Report to Planning and Environment Committee

Subject: Application By: Drewlo Holdings
1140 Fanshawe Park Road East
Public Participation Meeting

Date: May 9, 2022

APPENDIX A
SUBDIVISION LAYOUT

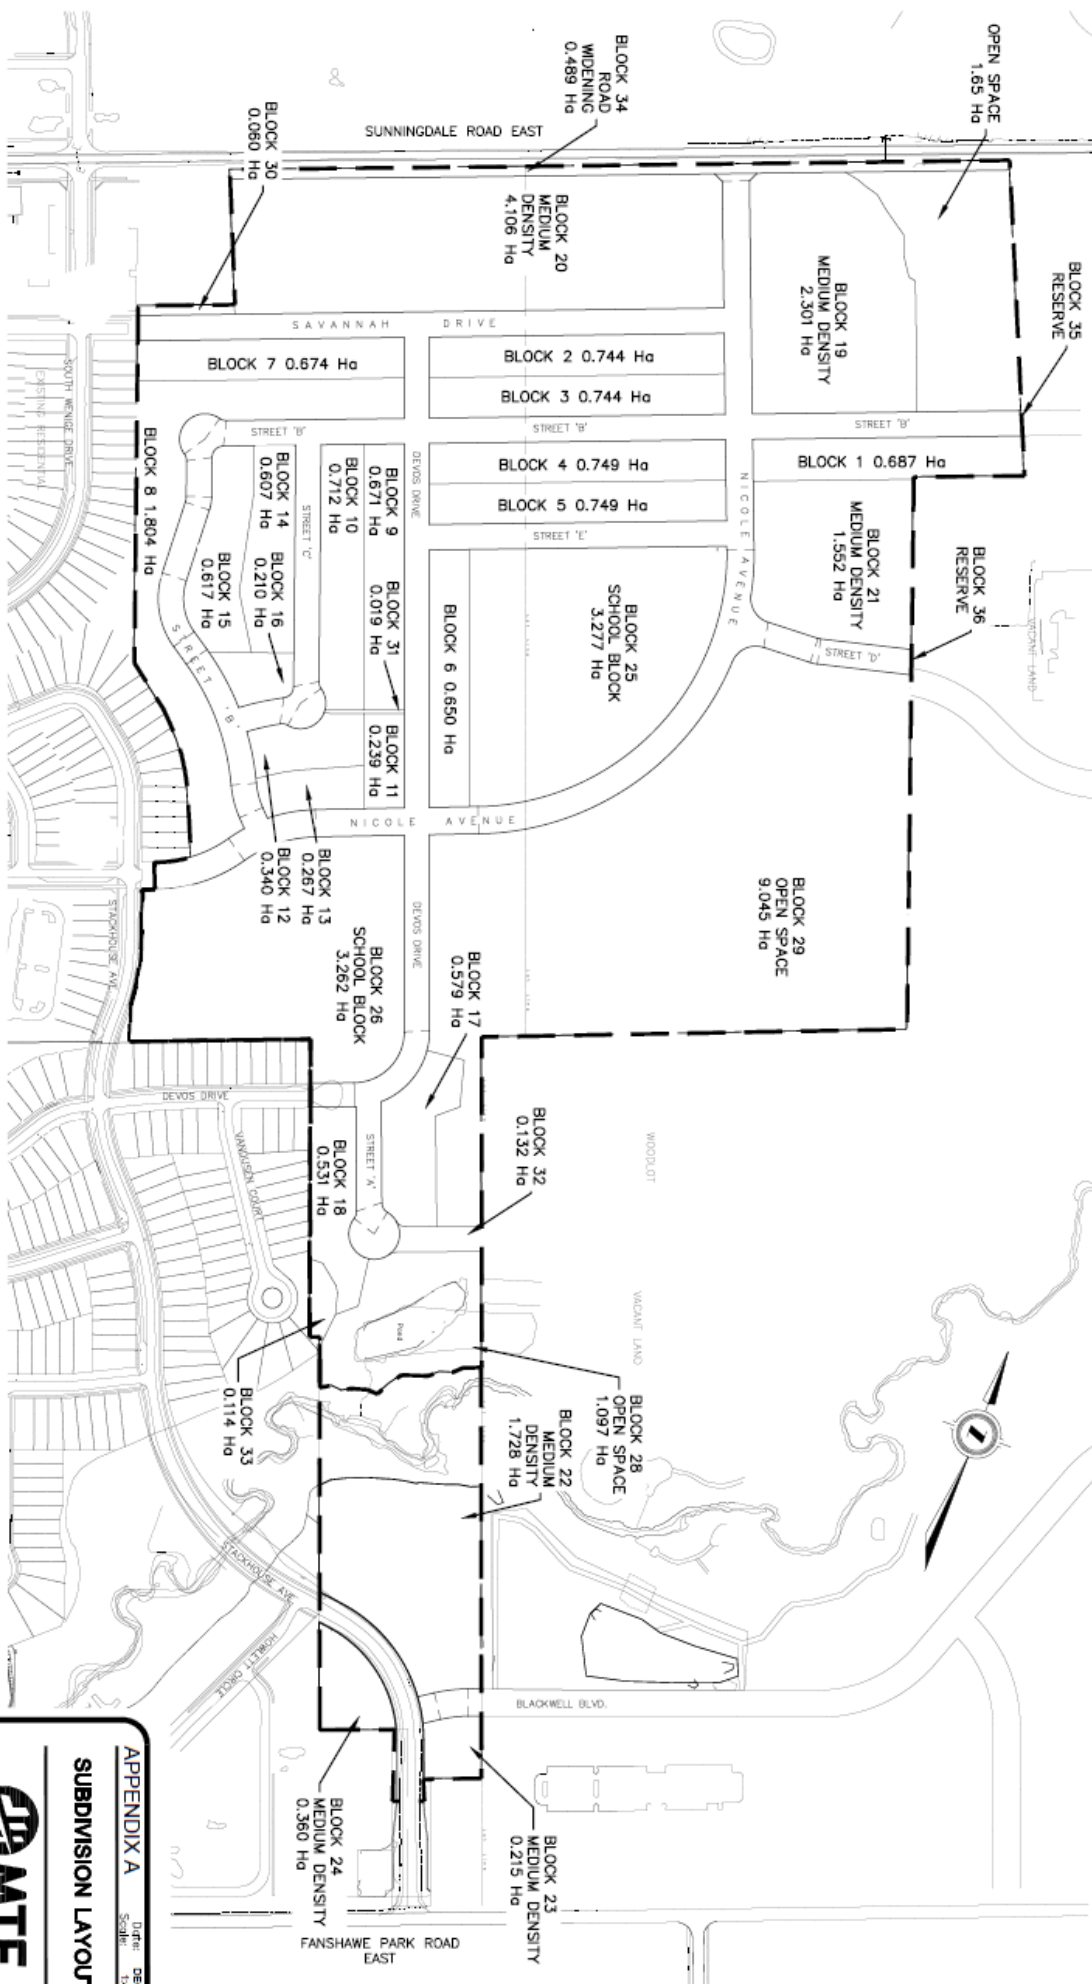
13. Block 22 encroaches into the wetland buffer/setback. Please revise.

21. Figure 15 provides a wetland design concept for Block 29, the proposed wetland compensation area. The EIS has recommended 30m setbacks from the existing wetlands, however only a 15m buffer is shown/referenced on the figure. Please depict the recommended buffer distance on the concept and ensure that the calculations for the wetland relocation area are not impacted as a result.

- a) Please confirm if the wetland compensation area includes a buffer within this calculation, or if the 6.61ha referenced on Figure 13 is solely devoted to wetland.
- b) While it is recognized that this concept is very preliminary in nature, insufficient information has been provided that details if this wetland relocation can succeed in this location.
